Title - Sujet Fuel System Upgrades	
Solicitation No. - N° de l'invitation EZ899-151543/A	Amendment No. - N° modif. 002
Client Reference No. - N° de référence du client	Date 2015-01-06
GETS Reference No. - N° de référence de SEAG PW-\$PWY-019-7401	
File No. - N° de dossier PWY-4-37229 (019)	CCC No./N° CCC - FMS No./N° VME
Solicitation Closes - L'invitation prend fin at - à 02:00 PM on - le 2015-01-08	
F.O.B. - F.A.B. Plant-Usine: <input type="checkbox"/> Destination: <input checked="" type="checkbox"/> Other-Autre: <input type="checkbox"/>	
Address Enquiries to: - Adresser toutes questions à: Ngan, Ken (PWY)	Buyer Id - Id de l'acheteur pwy019
Telephone No. - N° de téléphone (604) 658-2755 ()	FAX No. - N° de FAX (604) 775-6633
Destination - of Goods, Services, and Construction: Destination - des biens, services et construction: Parks Canada - Gwaii Haanas National Park - Gwaii Haanas, BC

This Solicitation Amendment 002 is raised to provide responses to additional questions received during the solicitation period.

Project: PWGSC Gwaii Haanas National Park
Ellen Island and Huxley Island Fuel System Upgrades
Project No.:R.068241.001
Contract No.: N/A

Addendum No.: 002

ITEM NO.: TH5G002200X12E DRN: RG Feb 24/11 SCALE: 1:18
JOB NO.: TH5G002200X12E DWG. NO.: TH5G002200X12E

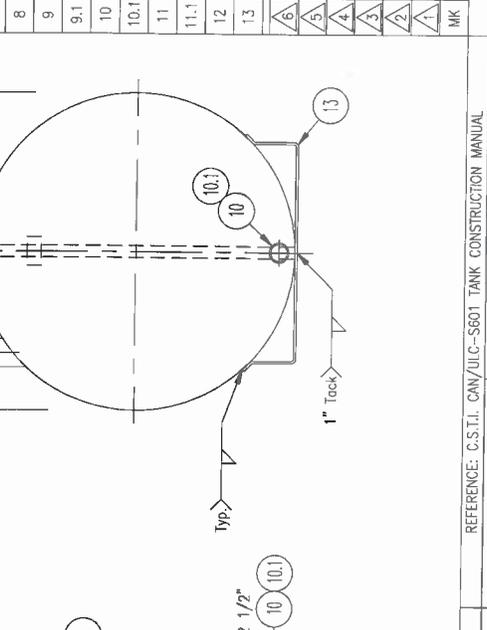
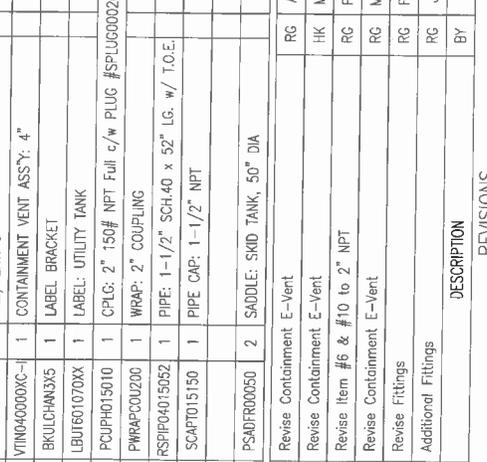
- f) *What is the weight of both the new and the old tanks?*
Answer: Approximate tank weight (empty) is 880lbs see attached generic shop drawing from Steel Craft.
